NAME & NUMBER OF PROJECT: Boat Dock for 5 Humboldt Lane
SP-2013-0133D

MEMORANDUM

SUBJECT: Boat dock for 5 Humboldt Lane, SP-2013-0133D

Project:	Boat Dock for 5 Humboldt Lane SP-2013-0133D
Ordinance Standard:	Land Development Code Section 25-8-281(C)(1)(a)
Variance Request:	To allow construction of a boat dock and the associated access trail within a Critical Environmental Feature (CEF) buffer.

SITE PLAN AND
CONSTRUCTION DETAILS

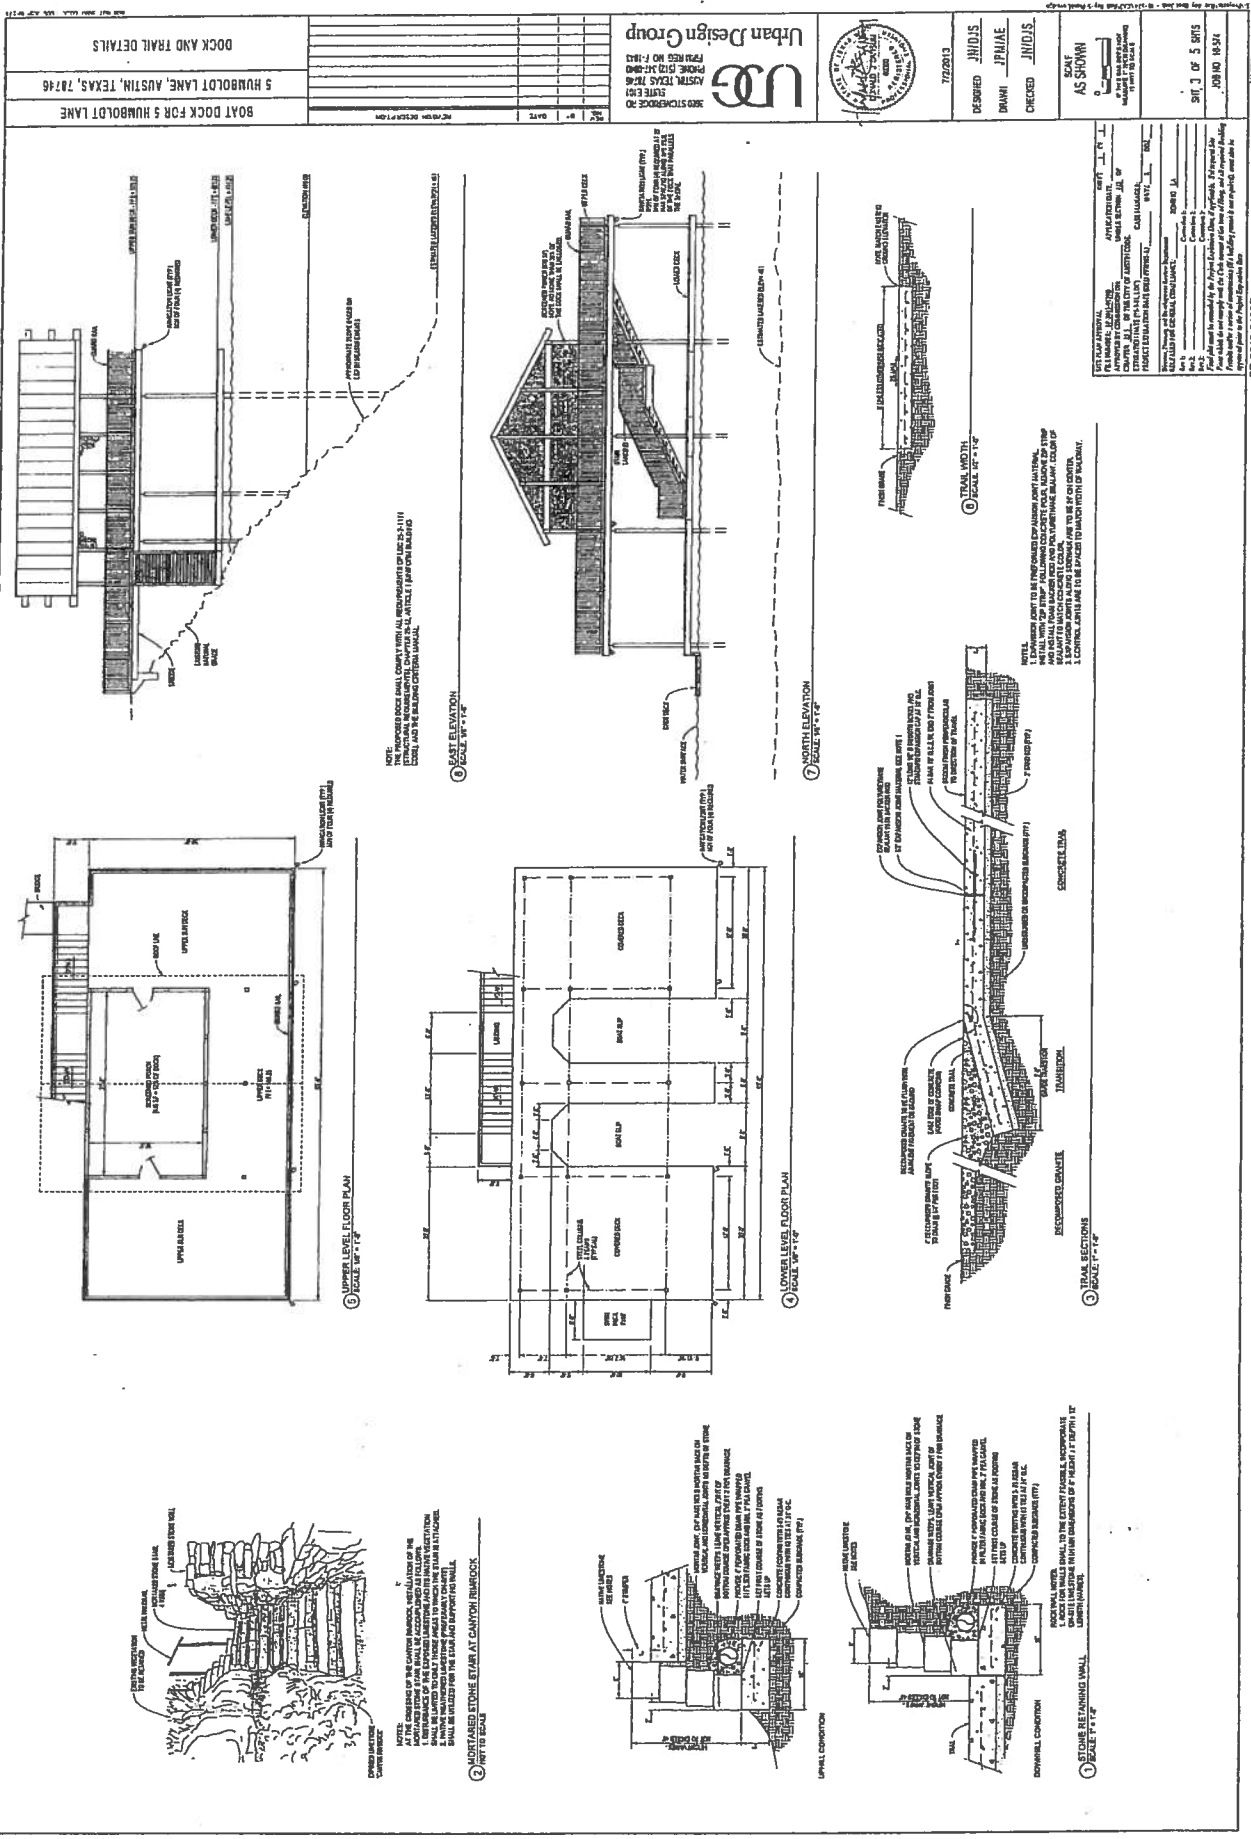
Along the steep portions of the access trail, the applicant will construct a mortared rock stair over and along the exposed edge of the rimrock. The construction details for the stair included on the site plan drawings stipulate that no disturbance of the rimrock or its vegetation shall occur except in those areas in contact with the stair. The applicant will utilize

PHOTOGRAPHS OF RIMROCK CEF
AT PROPOSED DOCK LOCATION

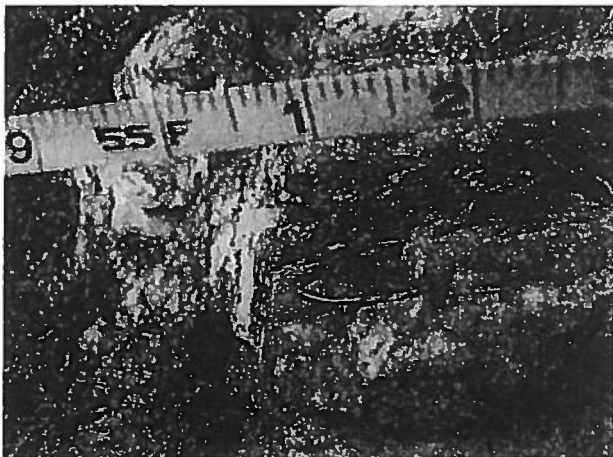
on-site weathered limestone to construct the stair in a comparable manner to the stairs built over a similar rimrock formation to access the dock located immediately upstream of the subject property. (See Attachment 3, Site Plan and Construction Details, Attachment 4, Photographs of rimrock CEF at the proposed dock, and Attachment 5, Photographs of stone stairs crossing rimrock to access dock on adjacent upstream lot)
